66319D-521-01

S E R V I C E N O T E

66319D with Option #521

Reliability Improvement of Instrument

CORRECT J207 PLACEMENT – alignment to within $< 0.3\text{mm}$

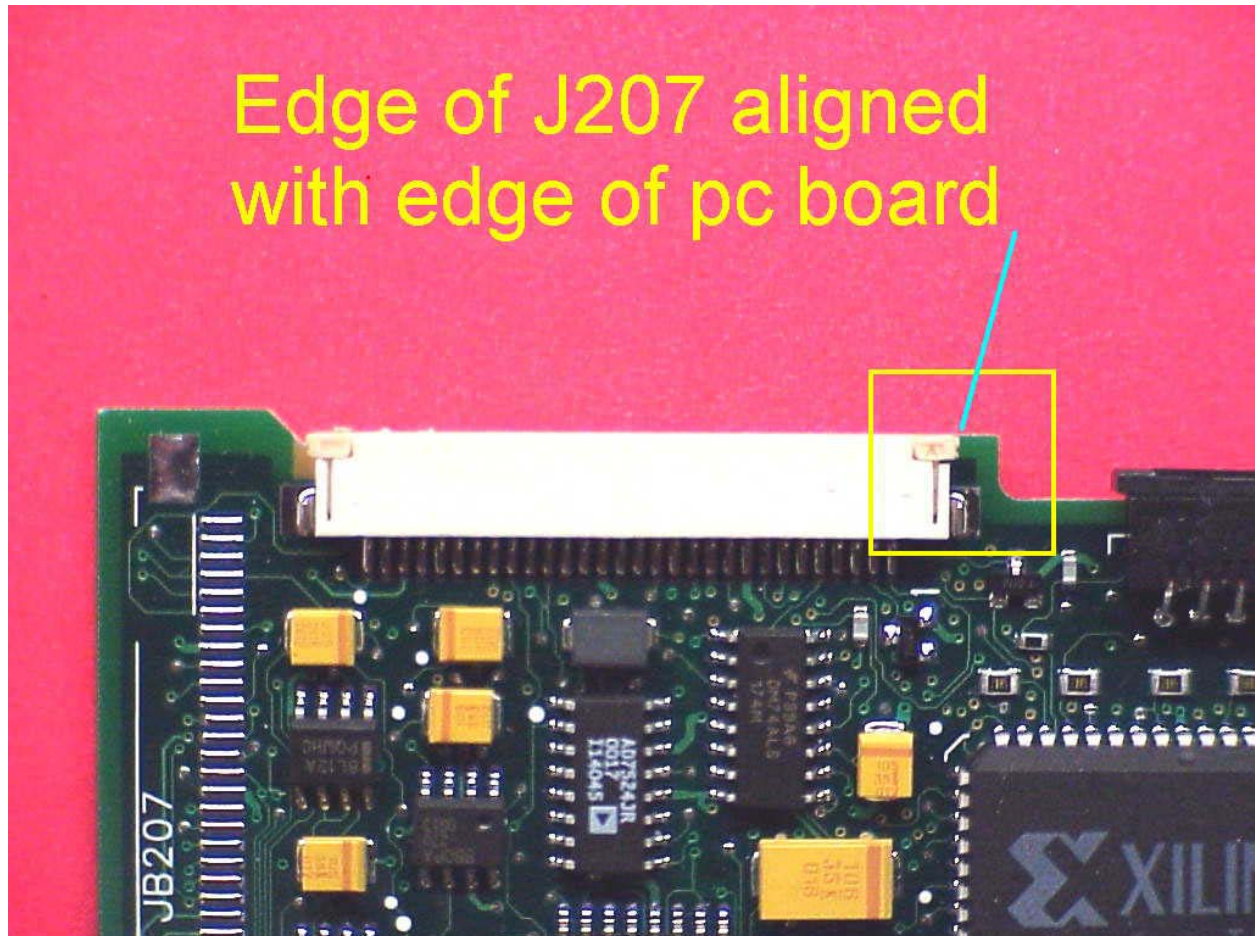
Latent product failure due to misplaced connector J207 on SMT assembly 5064-0018 (GPIB/RS232 interface). Misplacement of J207 could lead to inadvertent contact/shorting of exposed feed-throughs on SMT board. Ultimately, resulting in over-stress of components of damage to SMT board components. Resulting contact could degrade useful life of instrument.

Picture shows connector aligned to edge of SMT board to within $< 0.1\text{mm}$

- 1) Compare placement of J207 to attached photos. Instruments with a “misplaced” J207 should be returned to Agilent for warranty repair.
- 2) Instruments returned to the Service Center for routine calibration should be inspected for this potential defect. Defects should be addressed using Agilent’s unit exchange process with costs being charged to warranty.
- 3) The factory has modified production documentation to include visual inspection and specific electrical testing for this potential short.
- 4) Factory is maintaining feedback to SMT board supplier regarding quality of assembly.

INCORRECT J207 PLACEMENT – misaligned by $> 0.3\text{mm}$

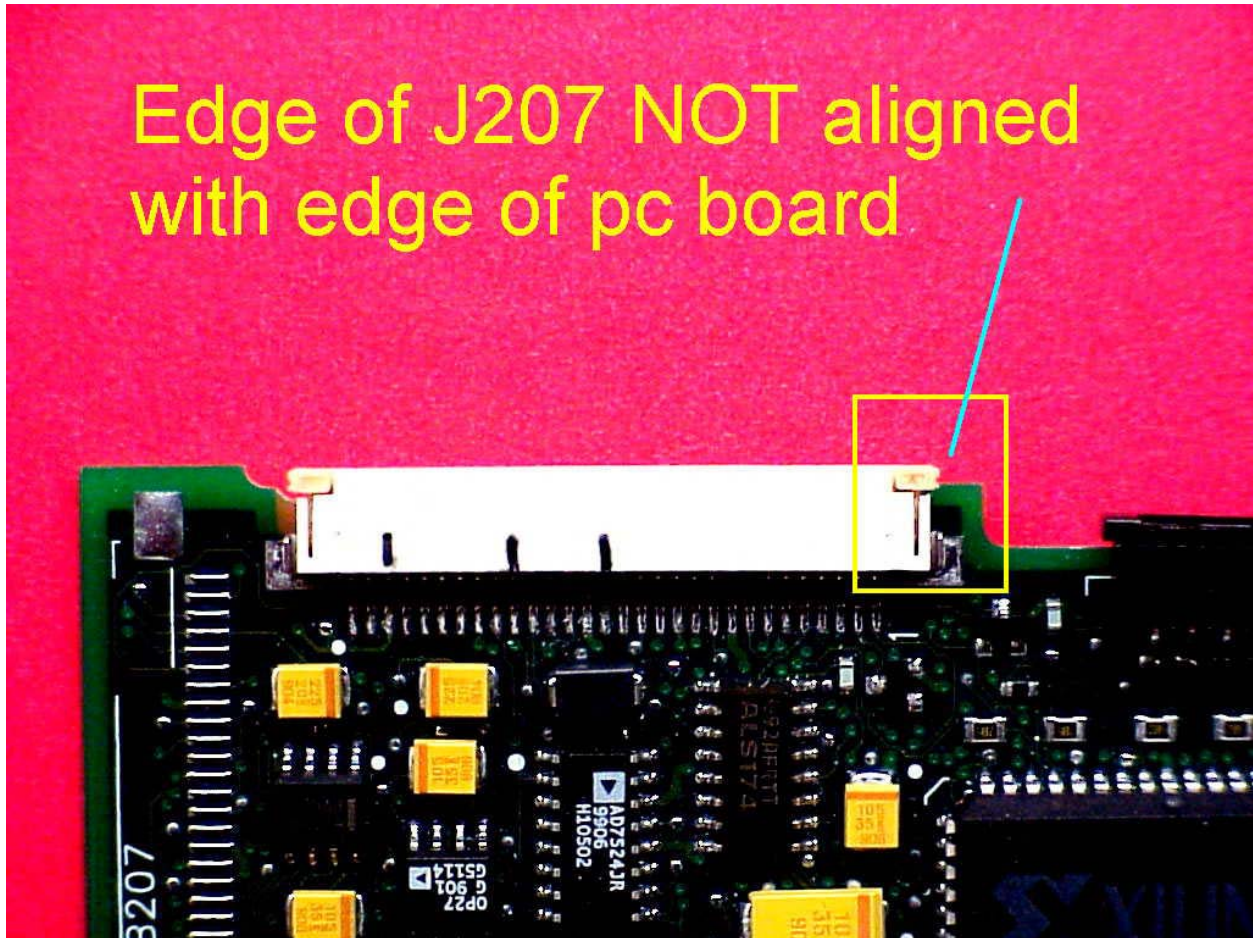
Picture shows connector extending past edge of SMT board by $>1.2\text{mm}$
